**Technical Memorandum**  
**Review of Aquifer Project Permit Application**  
**Gunnison Copper Project**

July 27, 2017

Excelsior Mining Arizona proposes to construct an in-situ leach and recovery copper mine near Dagoon, Arizona. This technical memorandum reviews the Aquifer Protection Permit Application for the Gunnison Copper Project.

**Figure 13: Figure 21 from CCA (2016) Appendix I showing conductivity in model layer 1, the uppermost layer in the model.**

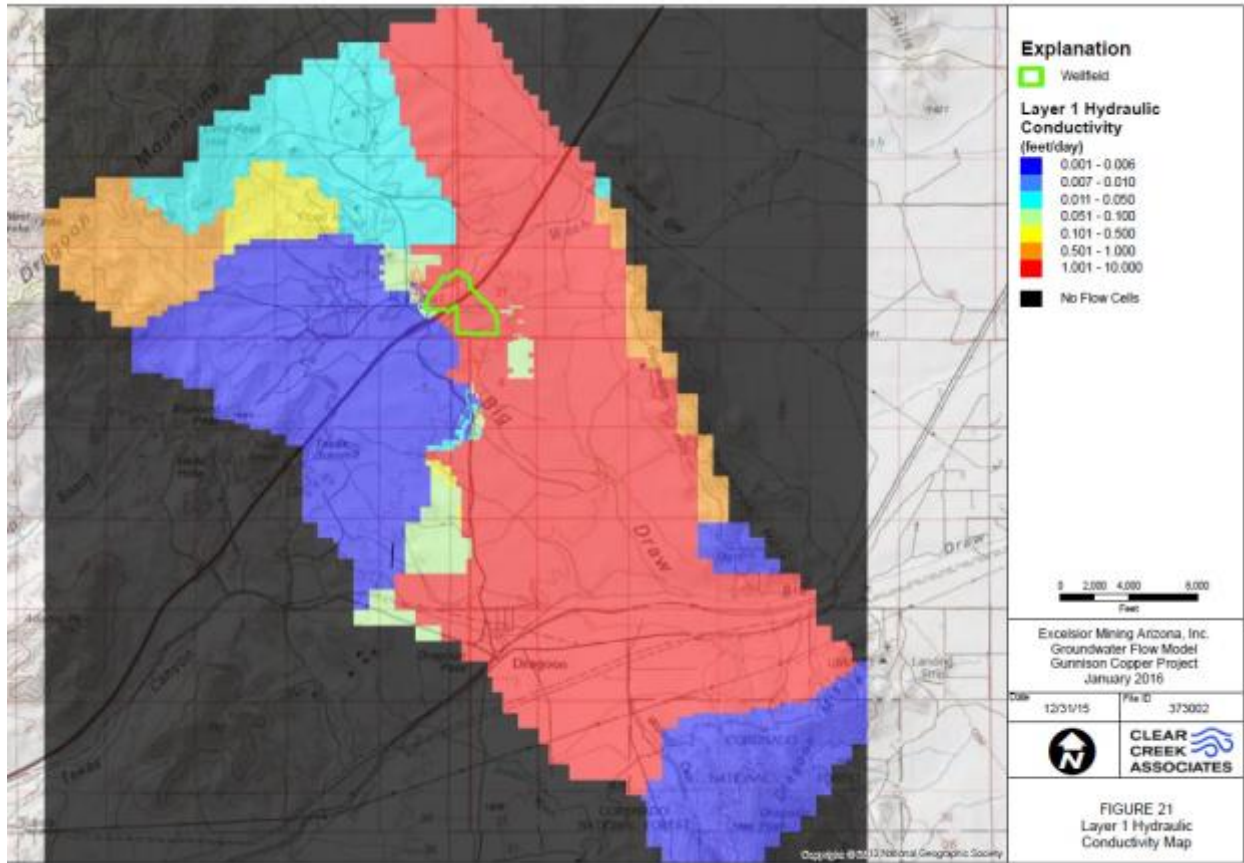
The low K in model layer 1 west of the well field (Figure 13) coincides with the high recharge in the Walnut Wash (Figure 12). This causes the higher groundwater ridge and steep slopes seen in the modeled steady state contours (Figure 14). Much of the remainder of the high recharge zones west of the project coincides with higher conductivity material in layer 1.

**Figure 14: Figure 33 from Appendix I showing groundwater elevation contours, residuals at observation wells, and residual statistics.**

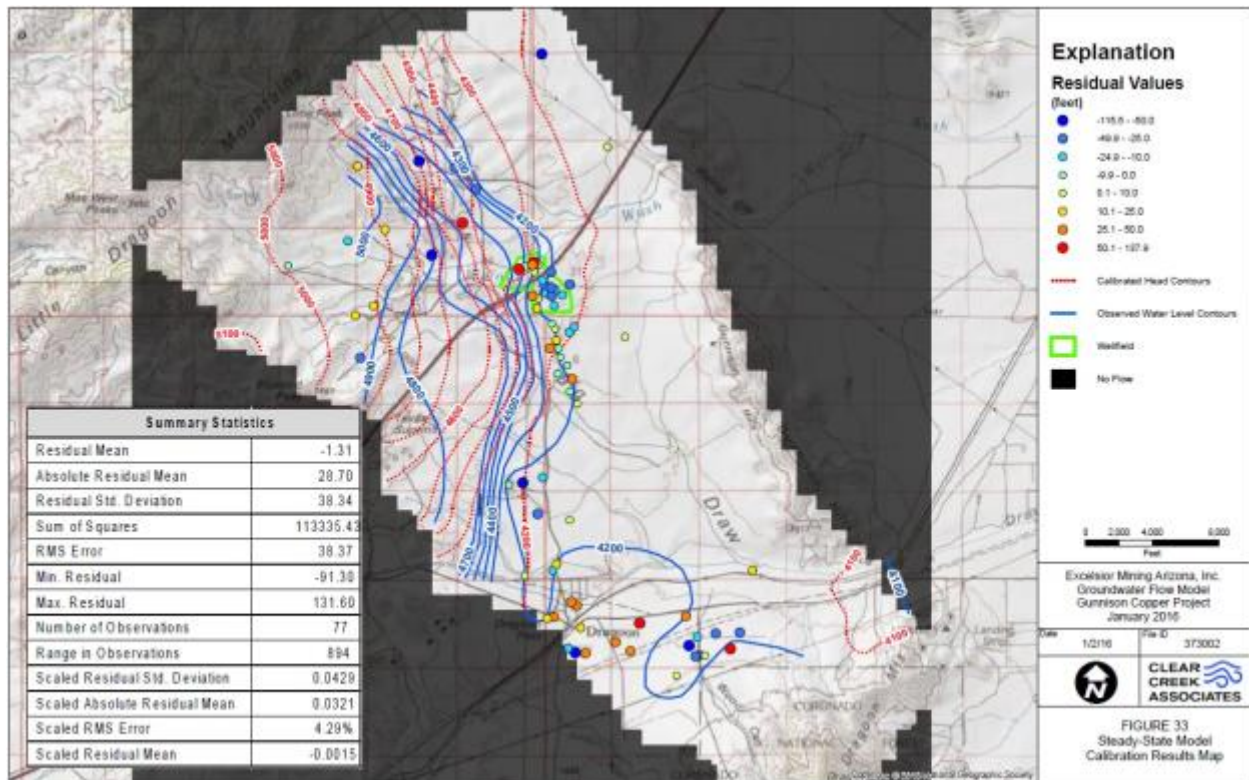
Figure 14 shows simulated and observed groundwater contours and residuals resulting from the final calibration. A residual is the difference between simulated and observed values. The simulated heads have a much more consistent gradient and resemble a surface much more than the observed heads. This probably reflects how the model layers represent average values over several fracture zones whereas the observation wells are monitoring different fracture zones. Simulated contour 4200 ft lies a couple thousand feet east of the observed 4200 ft contour which means the simulation results in a potentiometric surface above the observed.

The residuals through the wellfield area transition from high positive values, 50.1 to 137.9 with red circles to high negative values, -115.5 to -50.0 with blue circles over a short distance. The simulated potentiometric surface resembles an eastward dipping plane through a water table that is both far above and far below the plane. This could be the result of a flow barrier that causes the actual water levels to drop but is not included in the model or trying to match observed water levels from aquifers that are not connected. The rapid change in residuals across the site indicate the conceptual model for the area is inaccurate. It could assume connectivity among formations that does not exist, not considering horizontal anisotropy which would cause flow to trend in a certain direction and drop faster in other directions, or assuming more recharge which causes conductivity values that are generally too high. If the fractures trend NW-SE, as noted above, simulated east to west flow would be at an angle to the preferred direction based on fractures.

Figure 18: Figure 46 from Appendix I showing the progression of mining, in blue, and simulated hydraulic control wells.

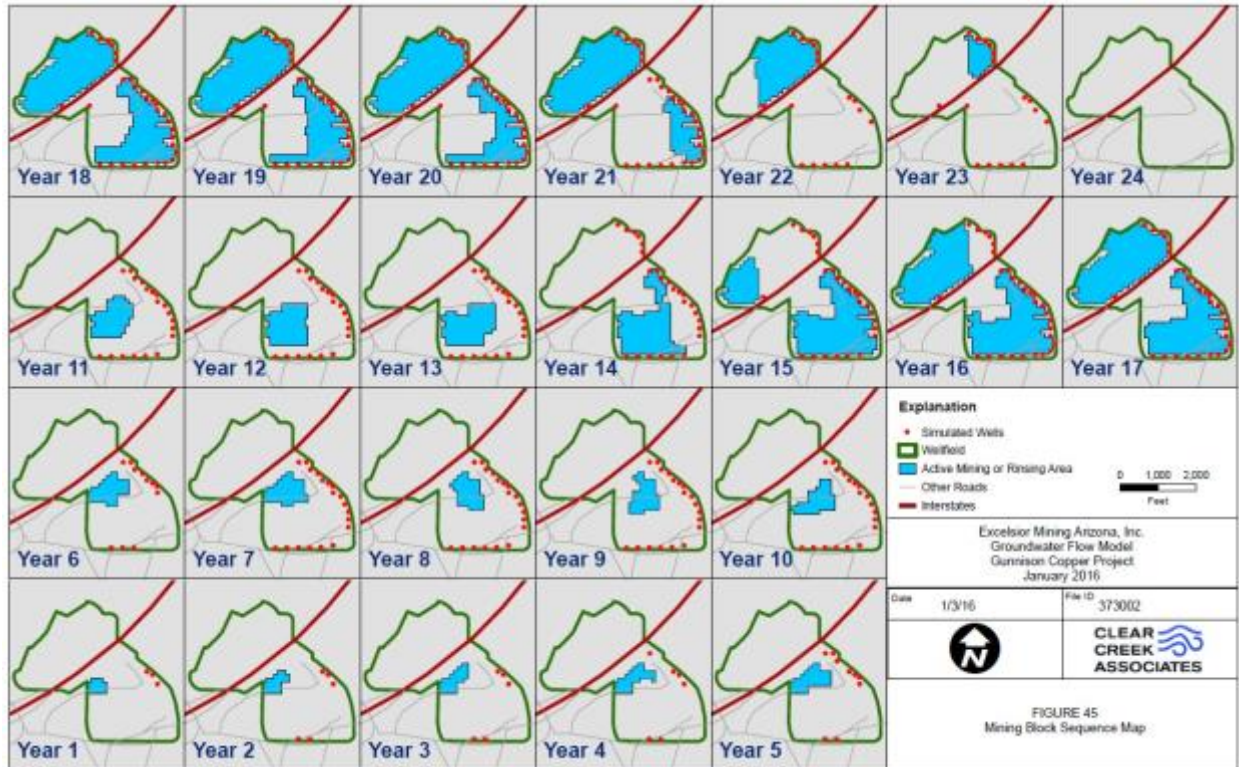
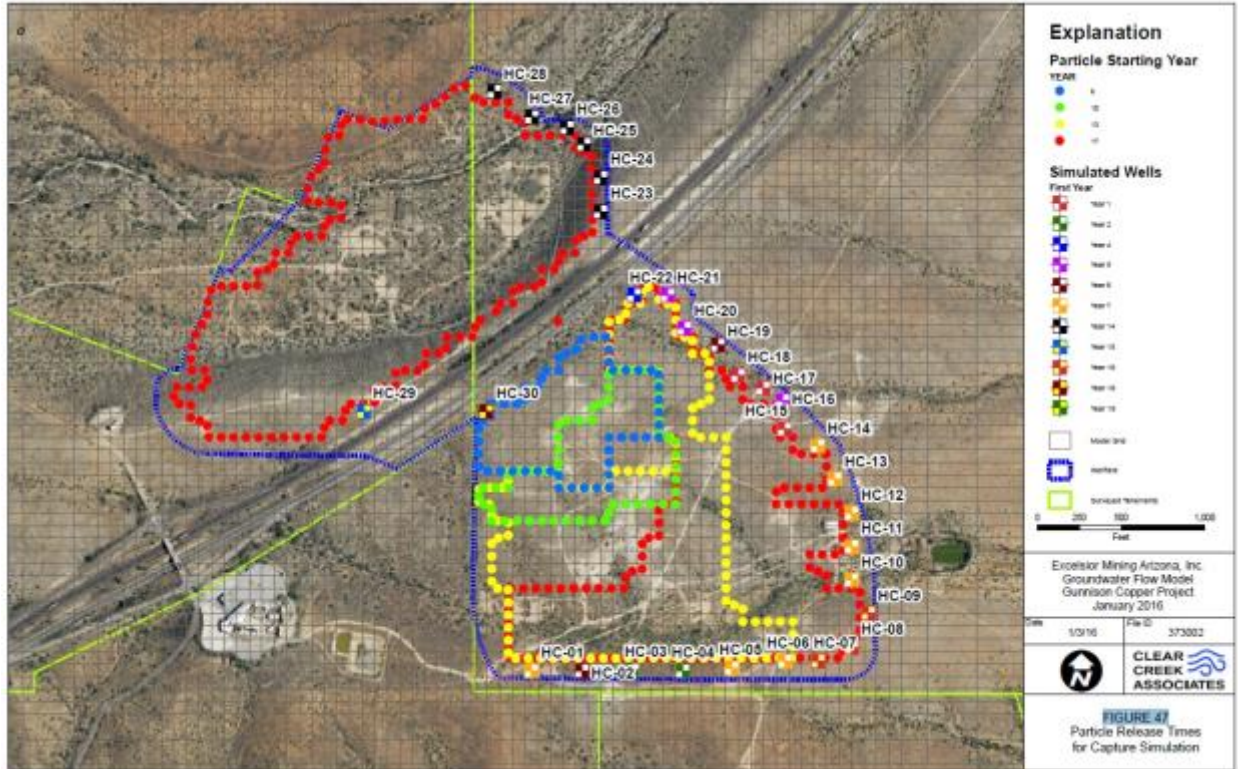
The model simulates pumping the hydraulic control wells that surround the well field, but does not simulate the 5-spot injection/collection regime within the well field (Figure 18). The hydraulic control well pumping was imposed on the steady state flow simulated in the calibration. Simulations ran for 23 years, simulating each year as a new stress as new blocks of injection/collection wells come on line (Figure 18). Pumping rates extend to only about 190 gpm total. Only hydraulic collection wells downgradient from operating injection/collection wells were operated during any given year. As may be seen from the annual drawdown maps (Appendix I, Figures 48 – 56), drawdown centers on the hydraulic collection wells and the model simulated no groundwater level changes near the area being mined.

- Contaminants in the model would be released at the edge of the interior well fields (Figures 18 and 19), but they would not be under pressure as they will be during operations. During operations, the particles would be released at the beginning of a pressurized stream that would cause the particle to move faster than simply being placed at given levels in the aquifer.
- The model simulates pathways that are at a minimum 50-foot wide (model cell sizes) which means the properties are effectively an average over an area that wide. It completely misses the potential narrow pathways that could preferentially allow particles to exit the system.

- The actual injection/recovery wells should be simulated, with injection rates depending on the localized conductivity and pressures that would be acceptable for operations.
- The model should be discretized into much smaller cells at the mine so that injection/recovery can be simulated more accurately. This could include telescoping the regional model into a much more detailed model at the well field.
- The geology/fracture intensity model should be used at a smaller scale to provide more detail of flow paths through the well field.
- The POC wells should be redesigned according to results from the modeling. The flow model should be used with MT3DMS to simulate transport from the well field to the POC wells. Assuming sources emanating from various positions through the well field, the model could simulate a plume that POC wells should be positioned to detect.

**Figure 19: Figure 47 from Appendix I showing the location and times that contaminant particles are released for simulation.**

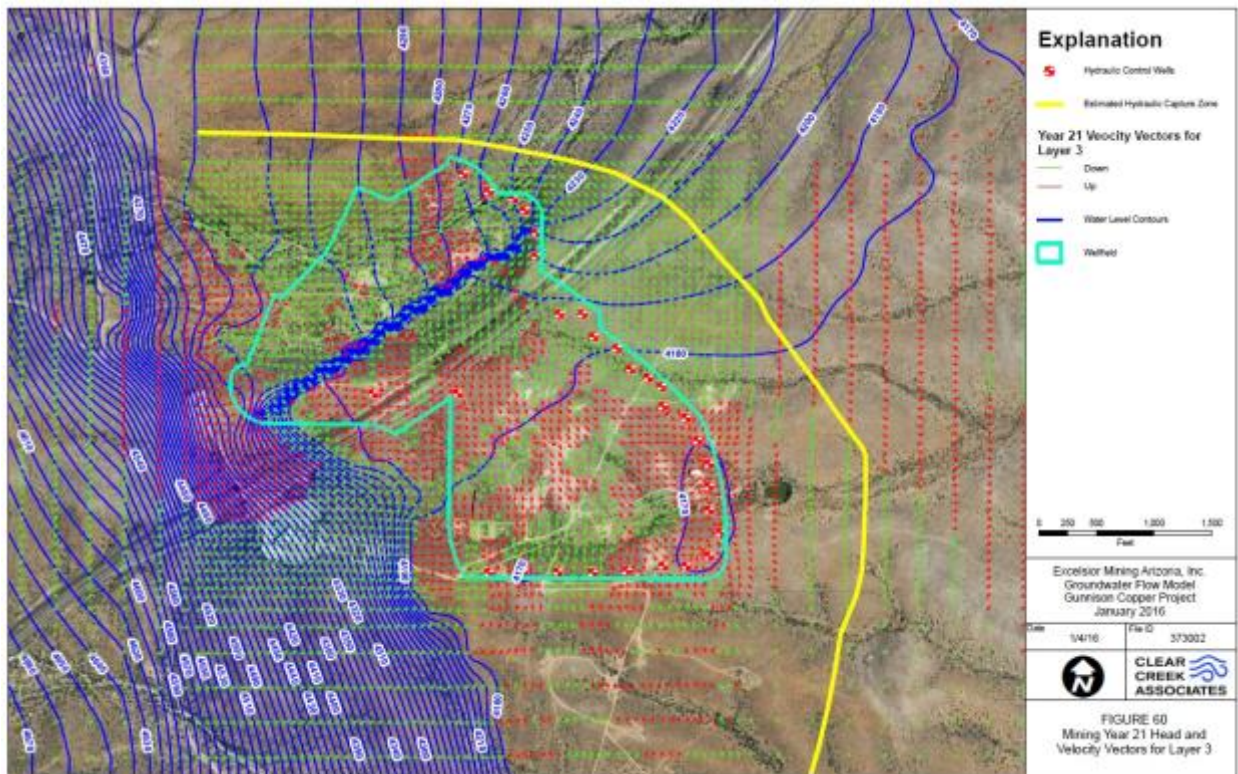
Particle track modeling shows that released contaminants would not escape the well field, but the modeling provides little confidence in the results. The particles follow the simulated flow paths, which are average flow paths that do not account for preferential flow paths through fracture zones.
